| | DESIGN RF | DRAWN BY | DART AEROSPACE L | ISA, I | NC. |
|--|--------------|----------|-------------------------|--------|----------|
| | | | PLUGS FOR D350-636-013, | / -014 | 4 NTS |

DART SERVICE INSTRUCTION

TO AMEND INSTALLATION DRAWING D350-636 REV. C

REF. CANADIAN STC: SH99-7 US FAA STC: SR00646SE

SECTION A-A

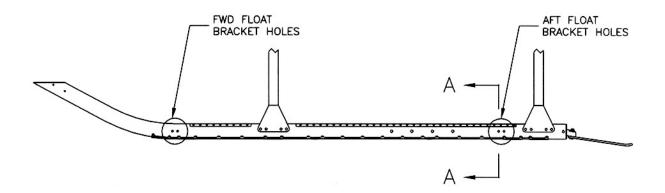
WHEN THE FLOAT SYSTEM IS NOT INSTALLED ON D350-636-013/ -014, THE FLOAT ATTACHMENT HOLES SHOULD BE PLUGGED AS SHOWN IN SECTION A-A BELOW.

AN3-32A BOLT (1) A3235-020-935 PLUG (2) MS21042L3 OR MS21042-3 NUT (1) (4 PLACES)

SEAL THE PERIMETER OF THE PLUGS WITH SIKAFLEX-241/-291 (OR EQUIVALENT) SEALANT (8 PLACES)
